TO ALL BIDDERS: Proposed Remodeling for: Ashland City Hall - Ashland, MO

THIS ADDENDUM SHALL SUPERSEDE THE PLANS AND SPECIFICATIONS INSOFAR AS IT IS IN DISAGREEMENT WITH THE SAME. HOWEVER, IT WILL IN NO WAY RELIEVE THE CONTRACTOR OF ANY RESPONSIBILITY UNDER THE PLANS AND SPECIFICATIONS, EXCEPT AS HEREIN SPECIFICALLY STATED.

Addendum 01
Item A04

ITEM NAME: TWELVE DOOR EVIDENCE LOCKER.

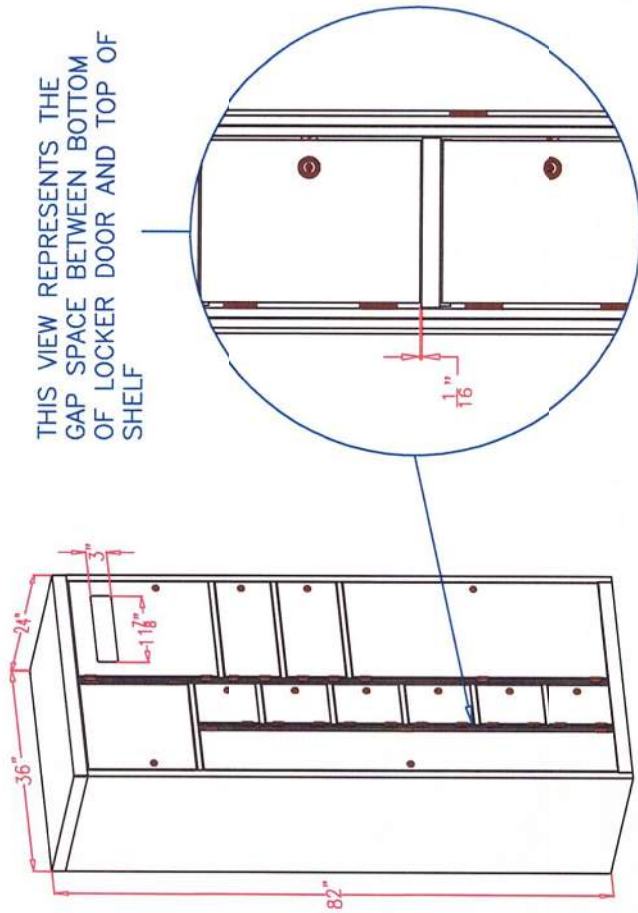
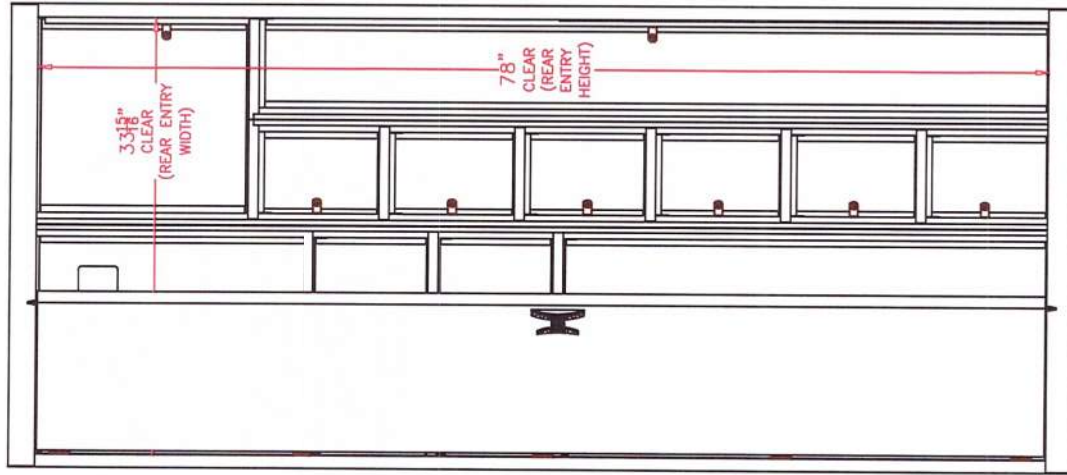
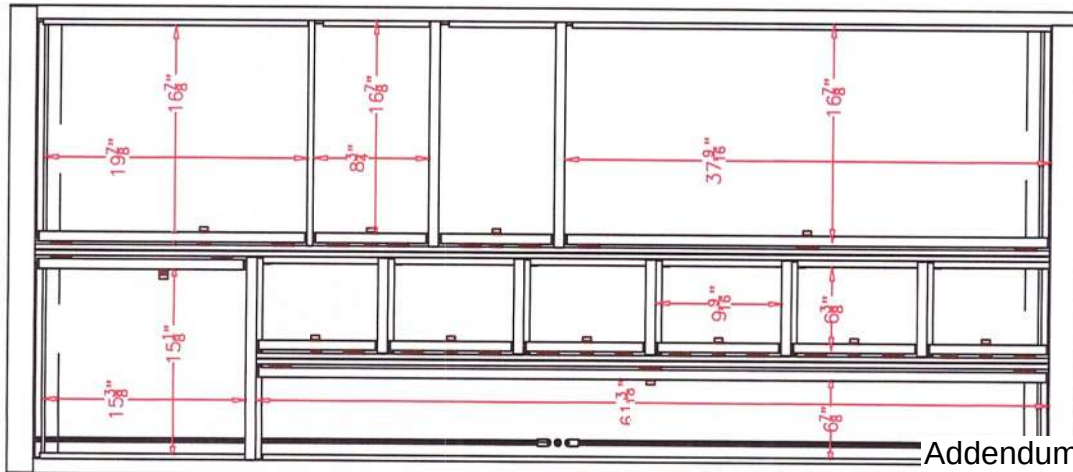
Item No. A04 – Clarification – Drawings – Sheet A401 – Elevation “Corridor 135”
There will be two Evidence Pass-Thru lockers that will be provided by the owner.
MVE-MCC – MC-S-20213014 – See attached detail.
12 Door Pass-Thru Evidence Locker – 36” x 24” x 82”
The contractor is to provide rough-in framing and install the evidence lockers.

**3** MECHANICAL HVAC PLAN
SCALE: 3/16"=1'-0"

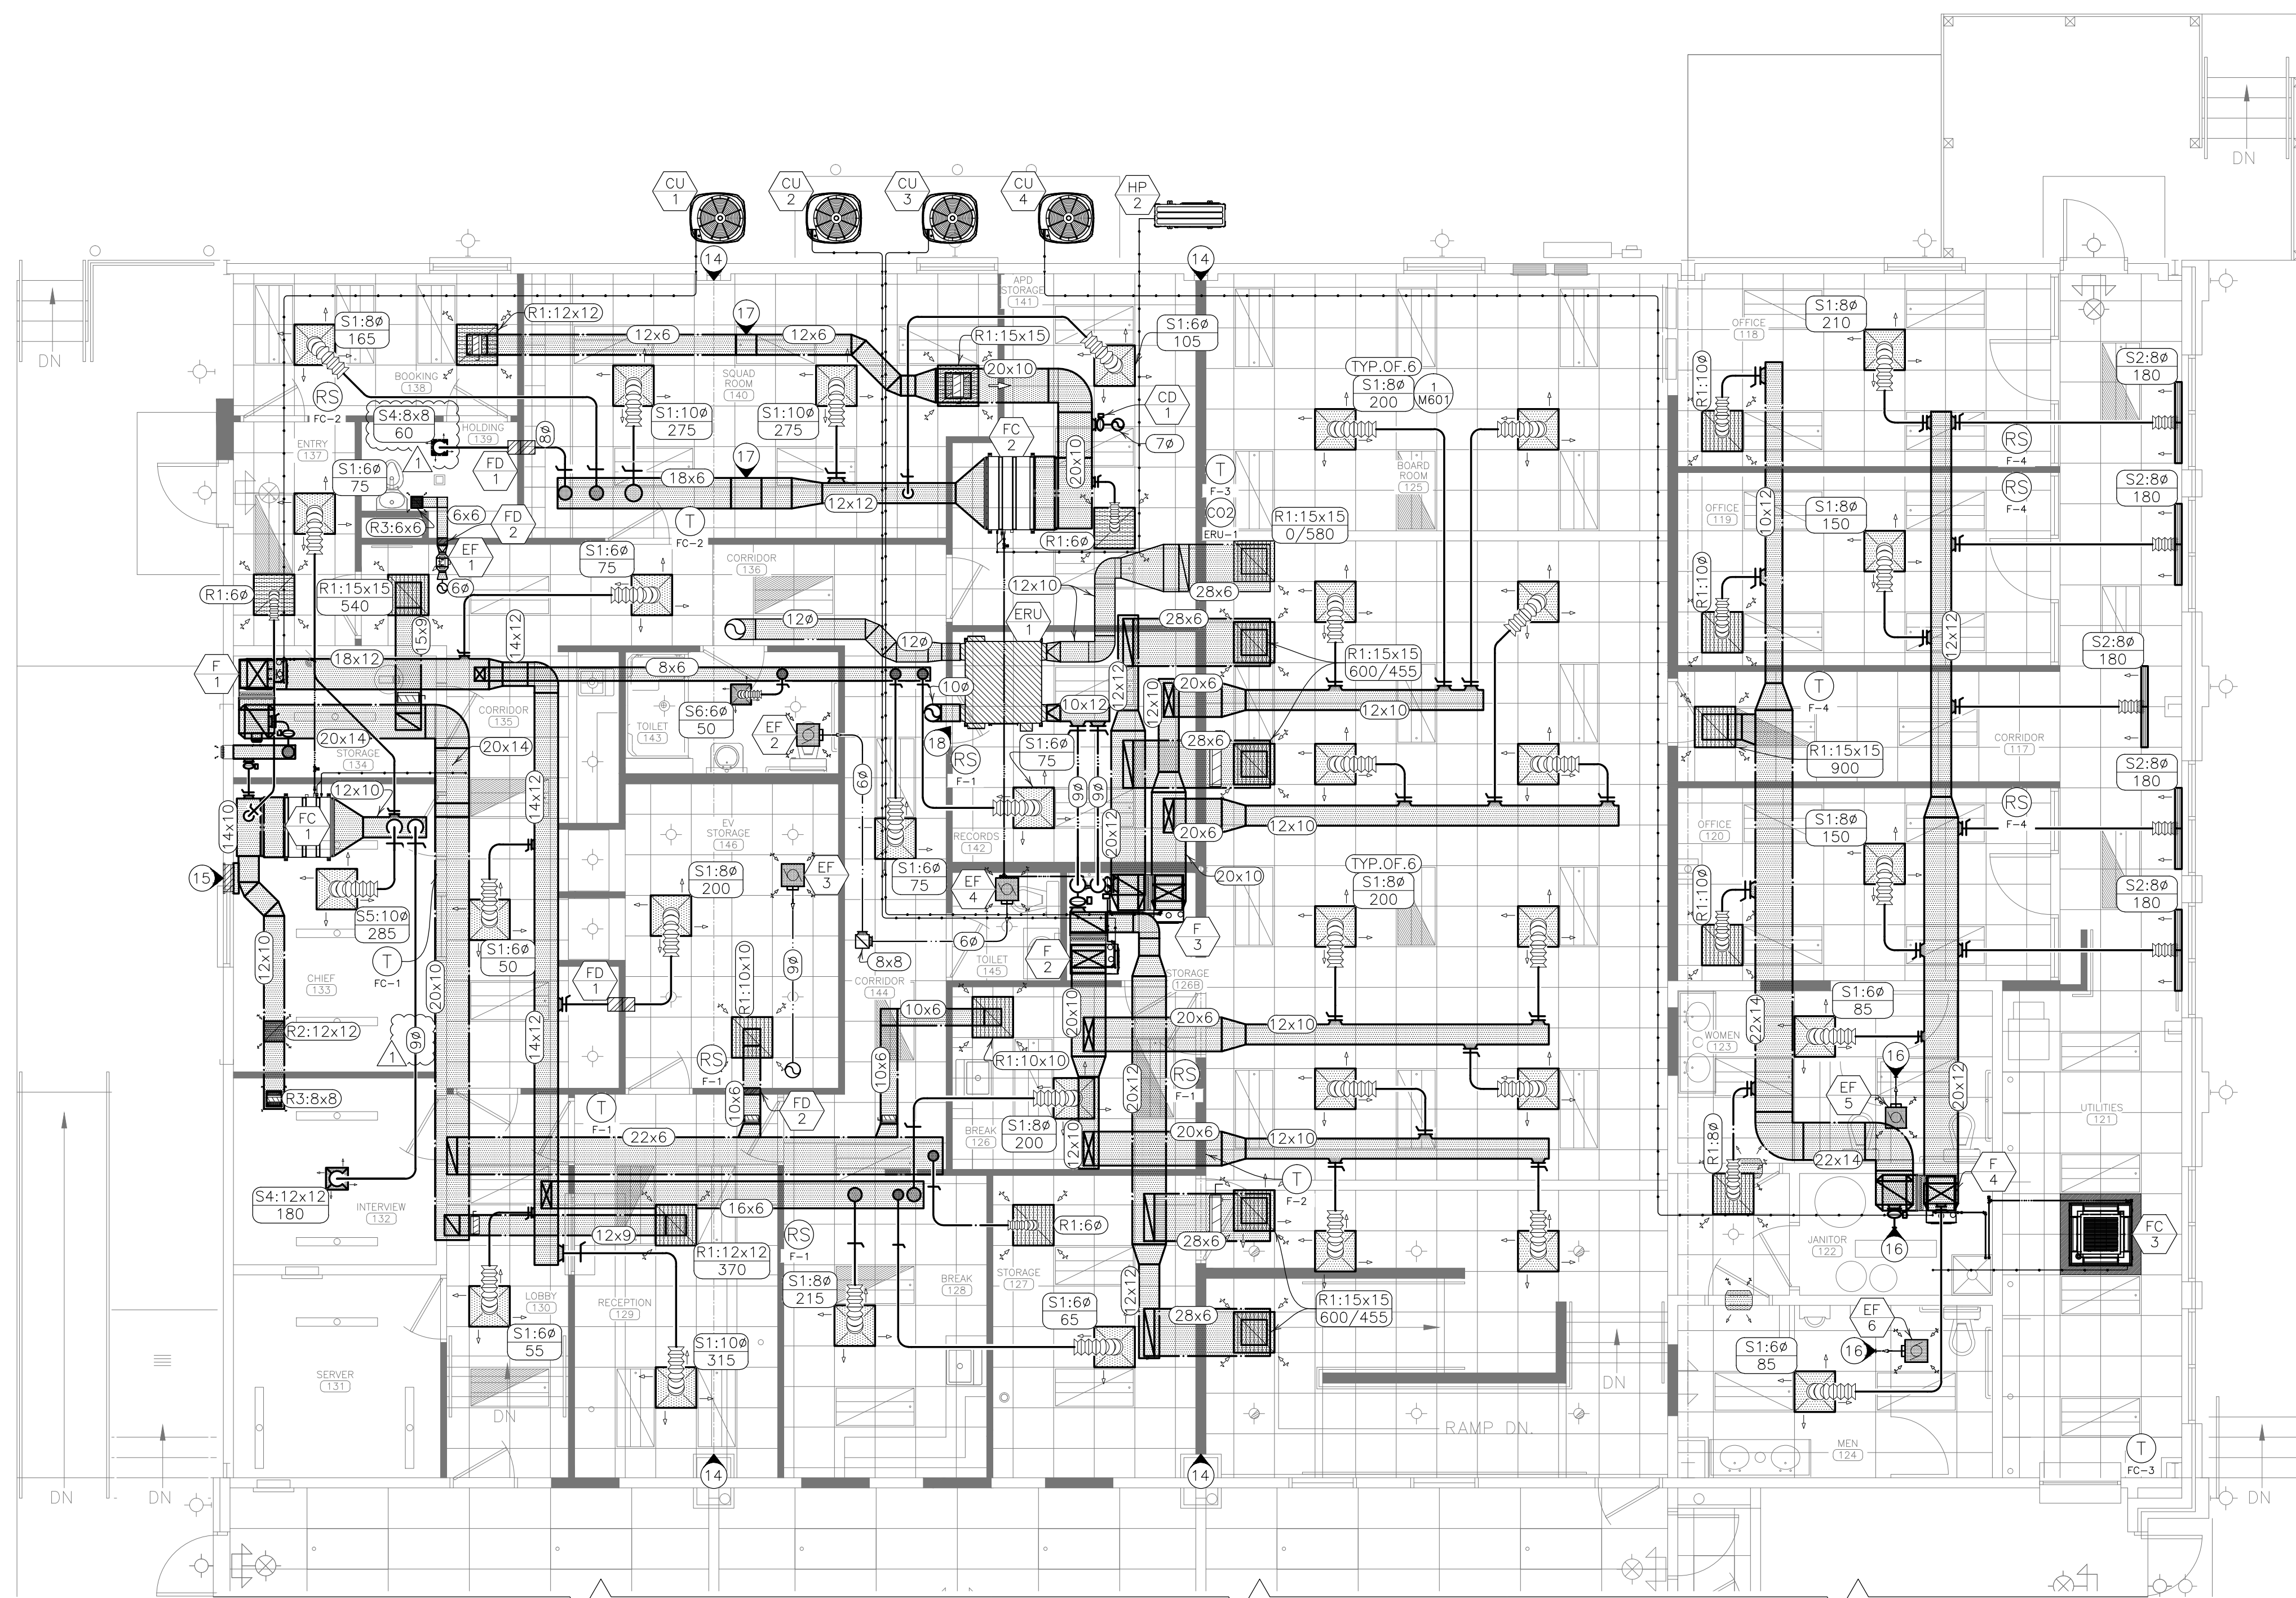
Item No. MEP01 – Clarification – Drawings – Sheets M102 and M601 are revised and re-issued.
Please see the two re-issued mechanical sheets attached.
Items of note:
1) Balance Damper information added on sheet M102.
2) Equipment changes on sheet M601.
